**BEFORE THE OFFICE OF THE REGIONAL FORESTER
REGION ONE – USDA FOREST SERVICE
Objection Reviewing Officer**

**NOTICE OF OBJECTION
PURSUANT TO
36 CFR 218**

Hungry Lion Resource Management Project Draft Decision Notice and Finding of No Significant Impact (hereafter Project, DN and FONSI)
Chip Weber, Flathead Forest Supervisor, May 2018.

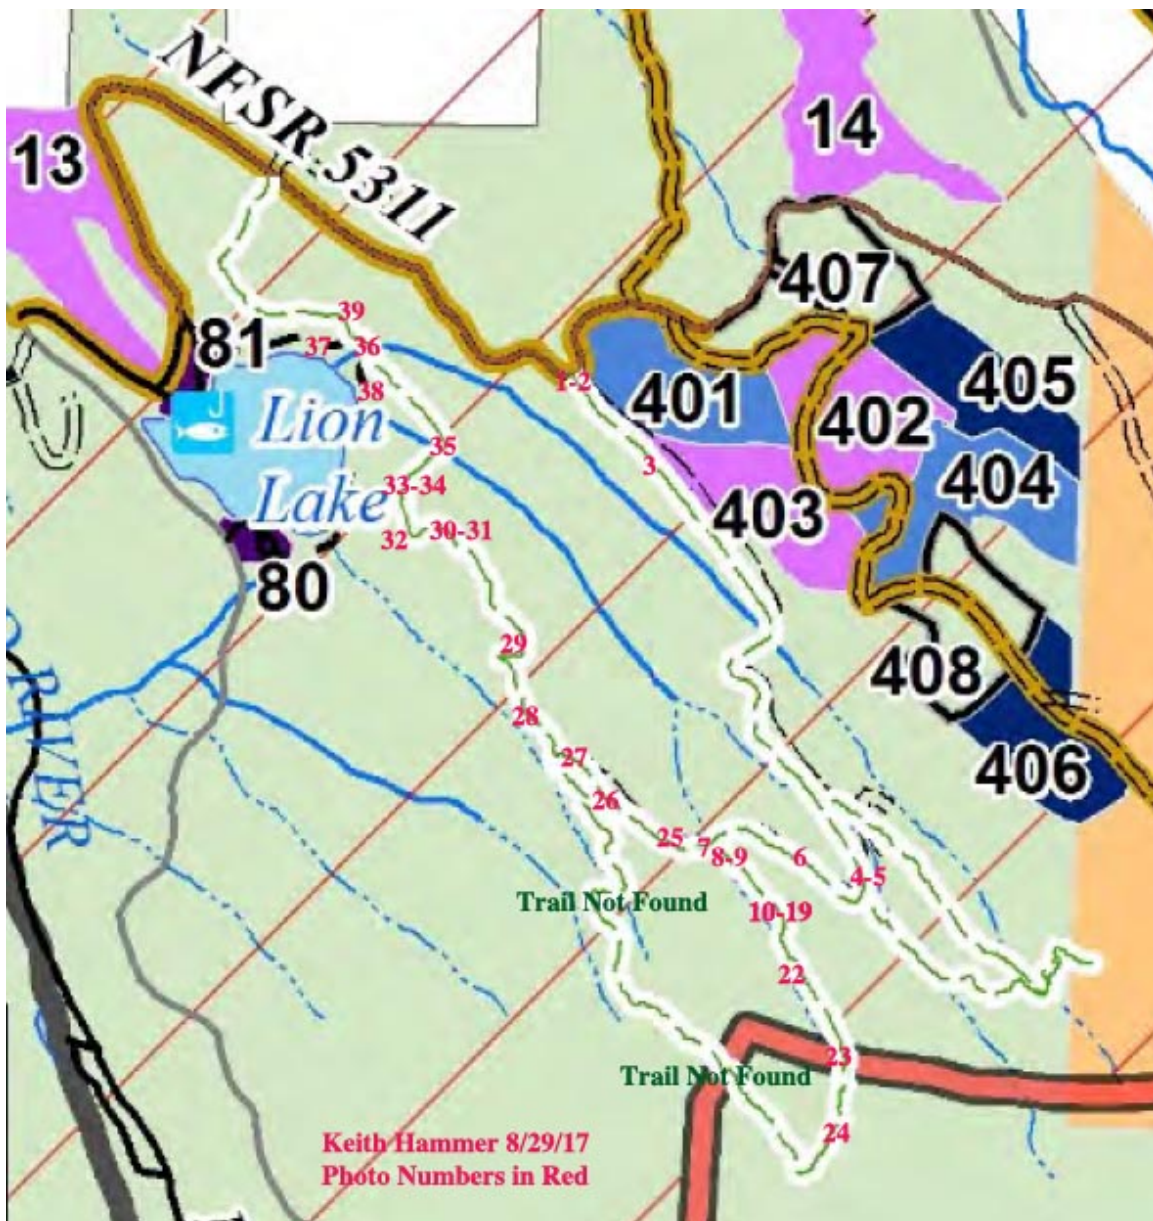
The DN and EA fail to adequately and fairly describe the bike trails proposed, especially in the Lion Hill area. They describe the proposed trails as “historic trail added back to system” (DN at 13 and 127). We hiked the majority of the proposed bike trails in the Lion Hill area on 8/29/17, took photos and found that only a portion of the proposed trails appear to be the historic trail to the old fire lookout location.

On the following page is a map of the approximate location of the sequential photos, shown on a portion of the DN’s Selected Alternative Map of the proposed trails. The numbered photos are in DVD Folder 28. Photos 1-9 are taken from closed road #5312, which is not an historic trail. Photos 4 and 5 are of a lightly used trail that appears to be on an old logging or skidding road, not an historic trail. We could not find the prior junction with this proposed trail loop and did not hike the loop, in order to focus on the historic trail to the old lookout and the reportedly high-use trail with the unlawfully constructed banked turns.

Photo 6 indicates that road #5312 does not receive heavy use to access the historic lookout trail. Photos 7-9 show that the high-use trail merely cuts across the end of road #5312.

Photos 10-19 show there is considerable use and unlawful construction of banked corners of the apparently historic trail above road #5312. Photo 18 shows a cigarette butt, something that comes along with trail access and never a welcome site on a hot August day during high fire danger.

Photos 22 and 23 help illustrate less use and maintenance is occurring near the top of Lion Hill and the old lookout site. Photo 24 shows older cutting of downfall beyond the lookout, with very little use of the trail tread apparent. We hiked quite a ways down the other side and could not find where the proposed trail curves back to the northwest. Nor could we locate the other end of this proposed trail where it is shown to reconnect with the trail running from the end of road #5312 down to Lion Lake.

Photos 25 - 36 show the proposed trail that does appear to get substantial use as it drops from the end of road #5312 down to the trail around Lion Lake. Photo 25 shows a wide corner that would likely be taken at even higher speeds by mountain bikers if the vegetation is trimmed back to provide longer line-of-site as proposed. Photos 25, 26 and 29 show jumps indicating bikes are using speed rather than caution. Photos 28 and 30-32 show corners that have been banked to increase bike speed. Photo 33 and especially 34 show where the trail has been widened to accommodate bikes jumping off the rock in the foreground and landing to the right of the trail tread (with a 42" hiking pole for width reference).

Photos 36 and 39 show that most of the trail-use goes to the North Lion trailhead and not north to road #5311.

In conclusion, the DN and EA misrepresent the existing situation as being significant public use of this proposed trail network and as a trail system that already exists as old historic trails. Where is a map of the historic trail(s)? Our field review found significant public use largely confined to the trail running from Lion Lake up toward the old lookout. The DN and EA fail to take the hard look and fairly describe the proposal as required by NEPA, leaving this looking like a Forest Service make-work project not confined to historic trails nor in response to documented recreation pressure and use.
